Work Order ID 89416

Item Name: Crosstube Aft

DRAWING NO. D412-664-243	TITLE CROSSTUBE ASSEMBLY (412 HI AFT)	REV. E	DART AEROSPACE LTD ENGINEERING ORDER		D.E.O. NO. D412-664-243-E-1	SHEET NO. SHEET 1 OF 2	SCALE NTS
DRAWN	CHECKED	MFG. APPR.	APPROVED	DE APPR.			
DATE 11.03.31	DATE 11/03/31	DATE 11.03.31	DATE 11/03/31	DATE 11.03.31

DRAWING NO. D412-664-243	TITLE CROSSTUBE ASSEMBLY (412 HI AFT)	REV. E	DART AEROSPACE LTD ENGINEERING ORDER		D.E.O. NO. D412-664-243-E-4	SHEET NO. SHEET 1 OF 3	SCALE NTS
DRAWN 90	CHECKED A	MFG. APPR. A	APPROVED MP	DE APPR. MP			
DATE 12.08.21	DATE 12.08.30	DATE 12.08.30	DATE 12/8/30	DATE 12.08.30

DRAWING NO. D412-664-243	TITLE CROSSTUBE ASSEMBLY (412 HI AFT)	REV. E	DART AEROSPACE LTD ENGINEERING ORDER	D.E.O. NO. D412-664-243-E-1	SHEET NO. SHEET 2 OF 2	SCALE NTS
DRAWN	CHECKED	MFG. APPR.	APPROVED	DE APPR.		
DATE 11.03.31	DATE 11.03.31	DATE 11.03.31	DATE 11.03.31	DATE 11.03.31

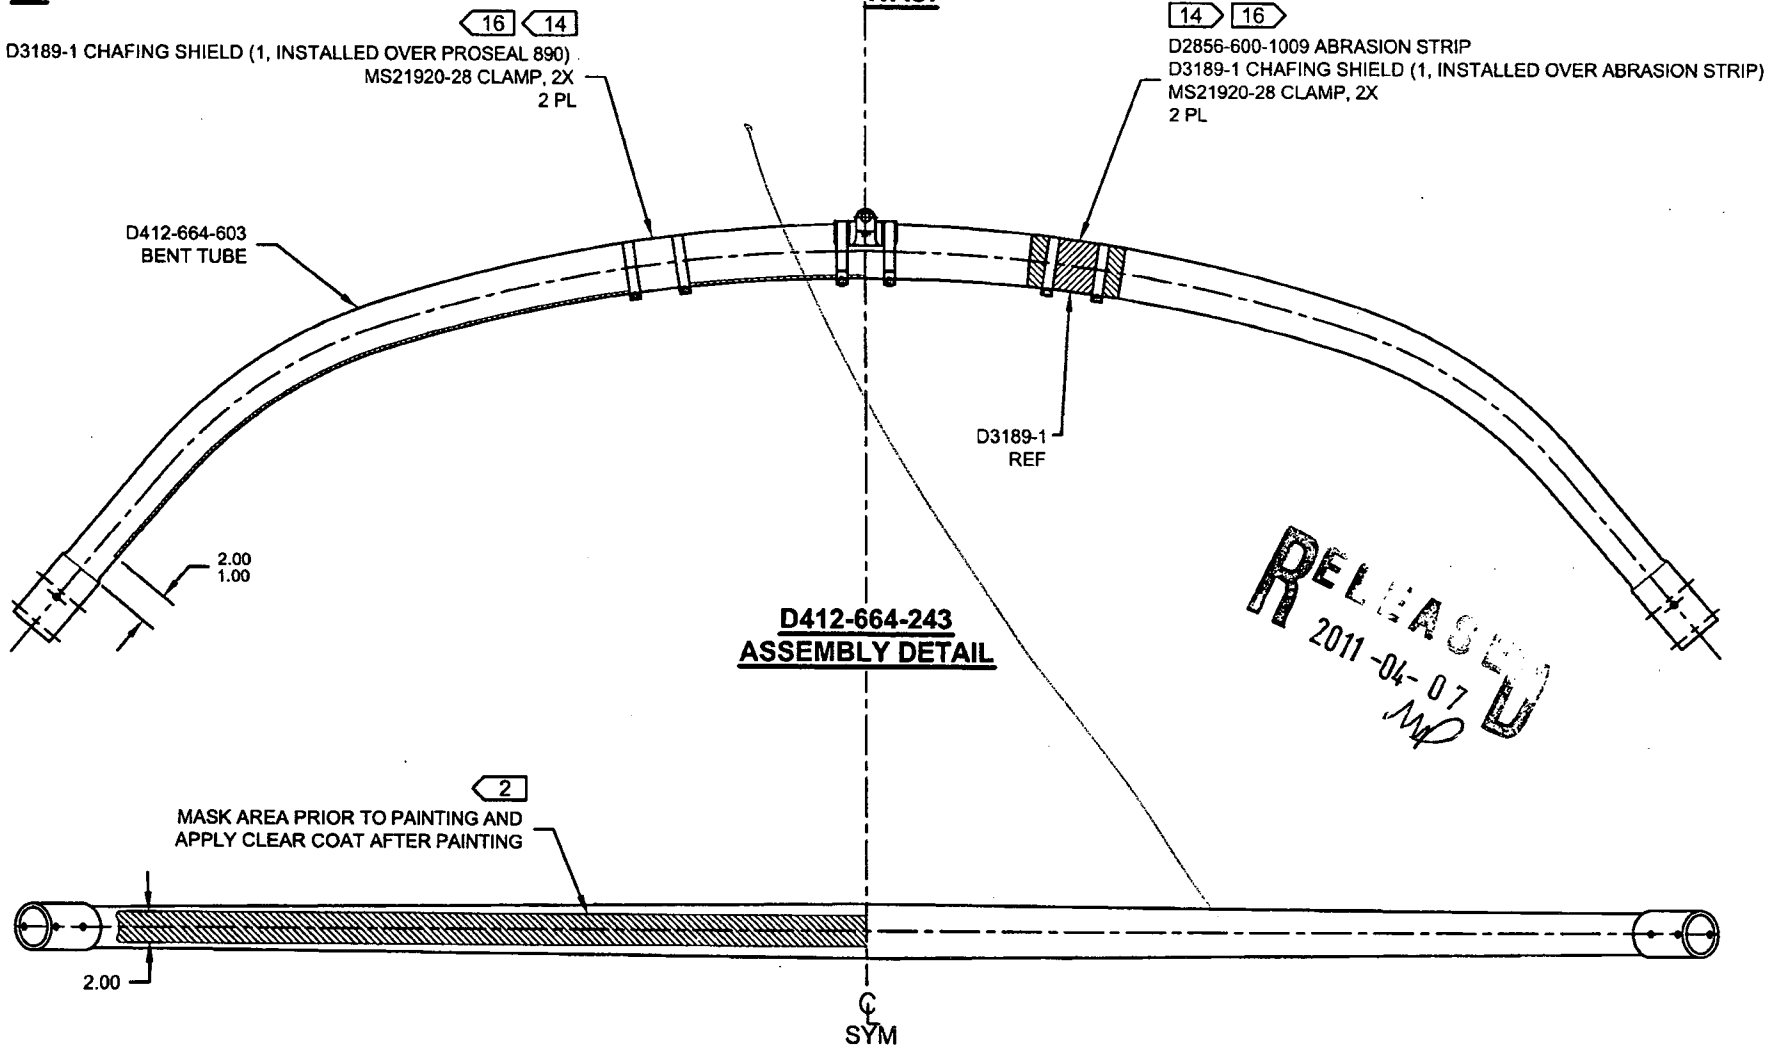
NOTES 2 AND 14, SHEET 1 ARE AMENDED AS FOLLOWS:

IS:

DRAWING NO. D412-664-243	TITLE CROSSTUBE ASS'Y (412 HI AFT)	REV. E	DART AEROSPACE LTD ENGINEERING ORDER		D.E.O. NO. D412-664-243-E-2	SHEET NO. SHEET 1 OF 1	SCALE NTS
DRAWN 97	CHECKED SS	MFG. APPR. E	APPROVED MP		DE APPR. H		
DATE 11.09.07	DATE 11.09.19	DATE 11.09.19	DATE 11.09.19		DATE 11.09.19

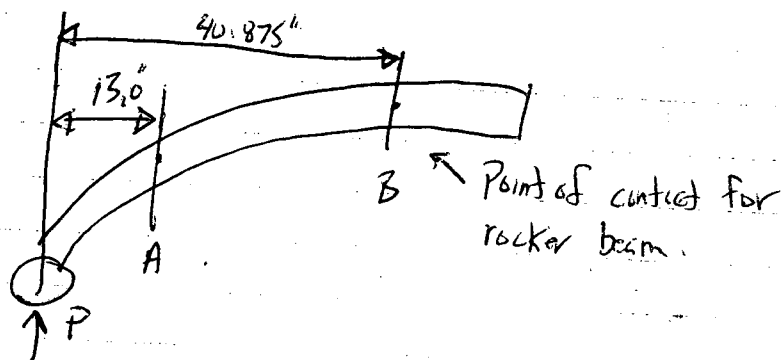
REPLACE MAGNOBOND WITH 3M DP460 SCOTCH-WELD EPOXY ADHESIVE

NOTE 12 & 16, SHEET 1 IS AMENDED AS FOLLOWS:

- 12) INSTALL D2896-1 CENTER SUPPORT USING A 0.04" TO 0.07" THICK LAYER OF SCOTCH-WELD DP460 PER QSI 015. LET CURE FOR 24 HOURS AFTER INSTALLATION AND PRIOR TO PACKAGING.
- 16) TORQUE CLAMPS 80 TO 100 IN-LB. ENSURE AT LEAST 1.5 THREADS SHOWING IN SAFETY AND THAT NUT HAS NOT BOTTOMED-OUT AFTER TORQUING. **PRIOR TO PACKAGING, RE-CHECK TORQUE ON CLAMPS AFTER ADHESIVE HAS CURED FOR 24 HOURS.**

- 12) INSTALL D2896-1 SUPPORT USING 0.03" TO 0.06" THICK LAYER OF MAGNOBOND 6398 TO THE SURFACE OF D2896-1 THAT WILL BE IN CONTACT WITH THE CROSSTUBE PER QSI 015. LET CURE FOR 12 HOURS AFTER INSTALLATION AND PRIOR TO PACKAGING.
- 16) TORQUE CLAMPS 80 TO 100 IN-LB. ENSURE AT LEAST 1.5 THREADS SHOWING IN SAFETY AND THAT NUT HAS NOT BOTTOMED-OUT AFTER TORQUING.

D412-664-603
BENT TUBE

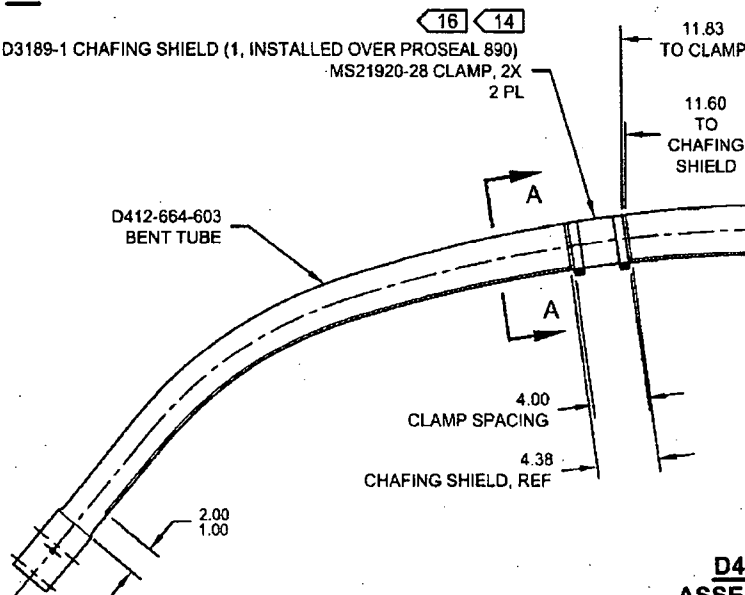
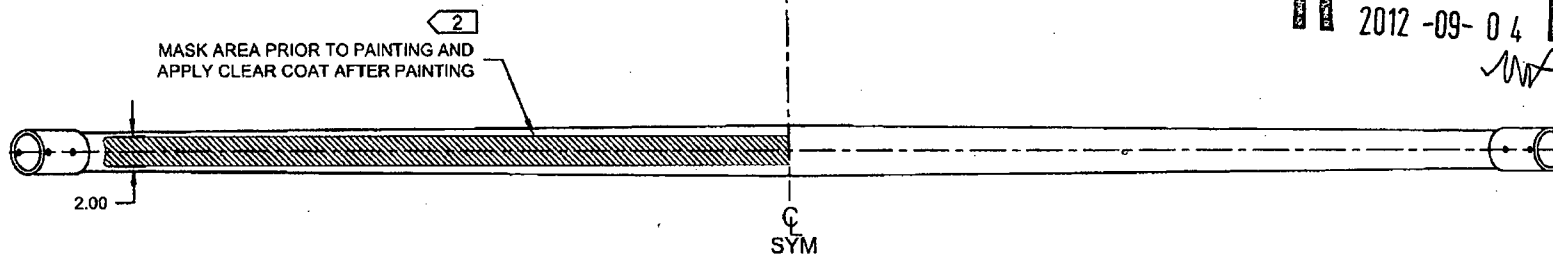
IS:

D3189-1 CHAFING SHIELD (1, INSTALLED OVER PROSEAL 890)
MS21920-28 CLAMP, 2X
2 PL

WAS:

D2856-600-1009 ABRASION STRIP
D3189-1 CHAFING SHIELD (1, INSTALLED OVER ABRASION STRIP)
MS21920-28 CLAMP, 2X
2 PL

SECTION A-A
CHAFING SHIELD DETAIL
VIEW ROTATED, NOT TO SCALE

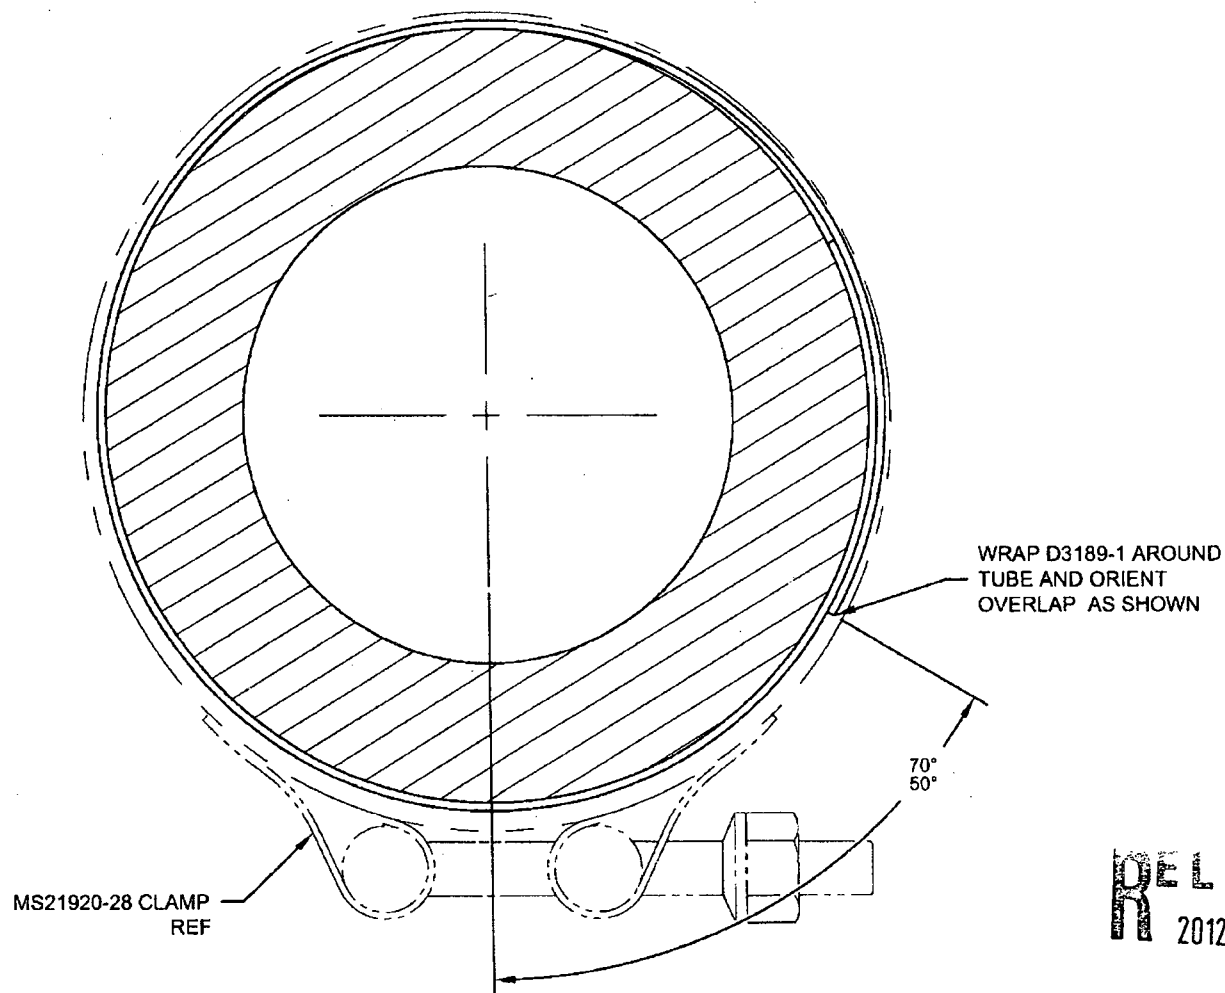
DRAWING NO. D412-664-243	TITLE CROSSTUBE ASSEMBLY (412 HI AFT)	REV. E	DART AEROSPACE LTD ENGINEERING ORDER		D.E.O. NO. D412-664-243-E-4	SHEET NO. SHEET 3 OF 3	SCALE NTS
DRAWN <i>MP</i>	CHECKED <i>MP</i>	MFG. APPR. <i>MP</i>	APPROVED <i>MP</i>	DE APPR. <i>MP</i>			
DATE 12.08.21	DATE 12.08.22	DATE 12.08.29	DATE 12.08.29	DATE 12.08.29	DATE 12.08.29
